UPDATED EXPERT OPINION ON THE ENVIRONMENTAL SAFETY OF IN-SITU LEACH MINING OF URANIUM NEAR MARSLAND, NEBRASKA (15 February 2018)

Hannan E. LaGarry, Ph.D.
55 Whispering Pines
Chadron NE 69337
hlagarry@olc.edu

Figure 1. Geologic cross-section of far western Nebraska showing proposed drilling near Marsland, the stratigraphic position of the Chamberlain Pass Formation, the positions of known faults, and the vulnerable portion of the high Plains Aquifer. After Swinehart and others (1985).

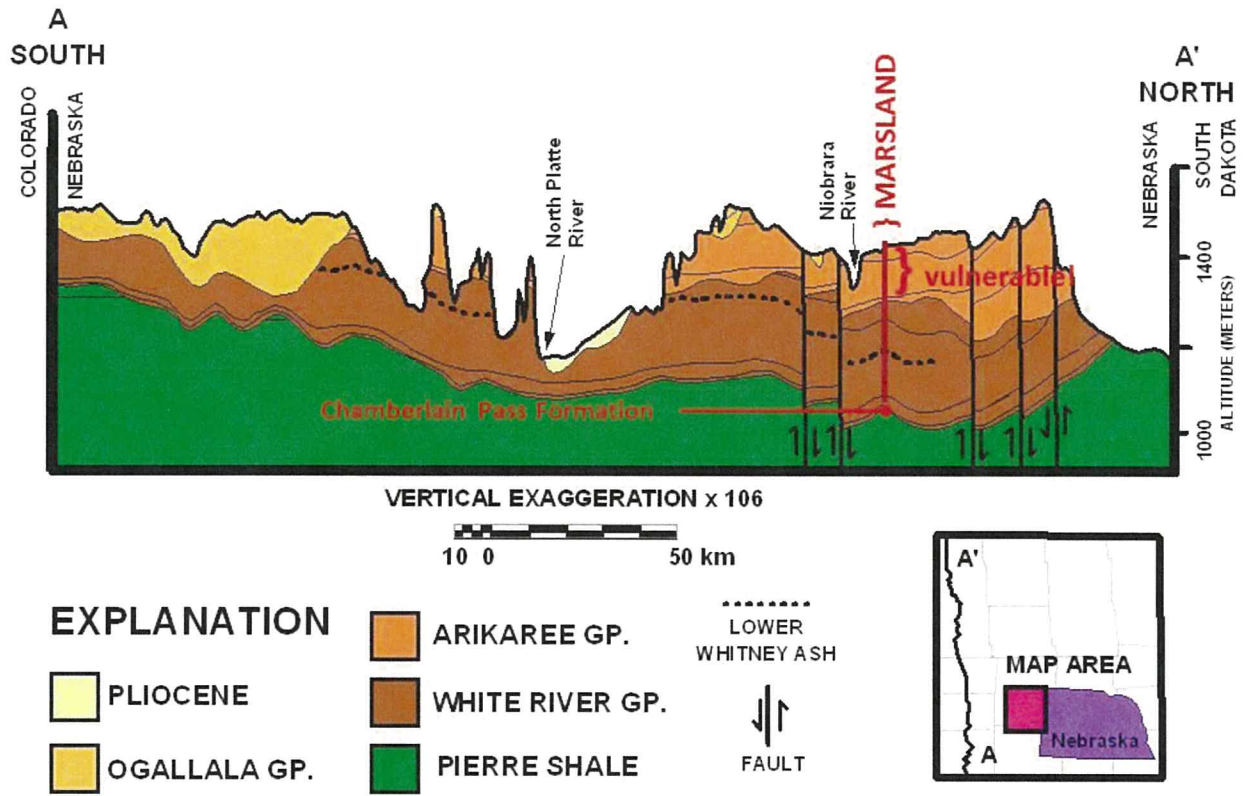
In-situ leach mining in the Marsland area would likely contribute toxic heavy metal contaminants, including but not limited to uranium, through three pathways: (a) surface leaks and spills, (b) underground leaks and spills (excursions), and (c) lack of containment. Once in the aquifer, contaminants would (d) migrate laterally through porous and permeable sandstones into the White and Niobrara rivers (Figure 1).

Surface leaks and spills. The soils in western Nebraska are thin, and directly overly permeable, porous bedrock. The rocks exposed at the surface near Marsland are either the Anderson Ranch Formation of the Arikaree Group or the Runningwater Formation of the Ogallala Group. Both are sandstone. Any leaks or spills onto the landscape would be transmitted directly into the High Plains Aquifer within a few years. There are no confining layers within this aquifer, and in some areas the water table is within 20 meters of the surface. Figure 1 shows the interval of the aquifer vulnerable to surface leaks and spills.

quickly spreading throughout the entire section of the aquifer. Under these rocks are the less permeable siltstones of the Brule and Chadron formations, which may contain useable water if sufficiently fractured (otherwise not). Below these are the uranium bearing rocks of the Chamberlain Pass Formation. Figure 1 shows the interval of the aquifer vulnerable to underground excursions.

Lack of containment. Diffendal (1994) showed that there are several potential faults in the Marsland area, and Swinehart and others (1985) show known faults both north and south of Marsland. These faults may allow the transmission of mining fluids to travel upward into the aquifer and laterally into adjacent areas to the west and east. The faults shown in Figure 1 are those that were large enough to be discovered by Swinehart and others (1985) who compiled data from ~12,500 drilling records in western Nebraska and conducted new drilling at 5 mile intervals along the transect shown. My work over the past 25 years has shown that there are likely hundreds more that are too small to be shown on such a diagram.

Lateral migration. Water in underground aquifers does not stay in the same place. It moves around laterally following the contours of the ancient landscapes the aquifer sediments were deposited onto. This water is also draw to wells (such as center pivots and stock tanks), springs (such as those that spawn the White River), and groundwater-fed rivers (such as the close-by Niobrara River). If contaminants were to escape into the High Plains Aquifer, within a few hears it could be drawn out of the ground and sprayed onto crops by center pivots, or be drawn to the surface by stock tanks placed to water cattle and horses. It would likely migrate eastwards (down gradient) and contaminate the White River, which supplies the towns of Glenn, Crawford, Whitney, and Pine Ridge with water. It could quickly find its way into the Niobrara River, which is a National Scenic River used by thousands of people for recreation every year (Figure 1).
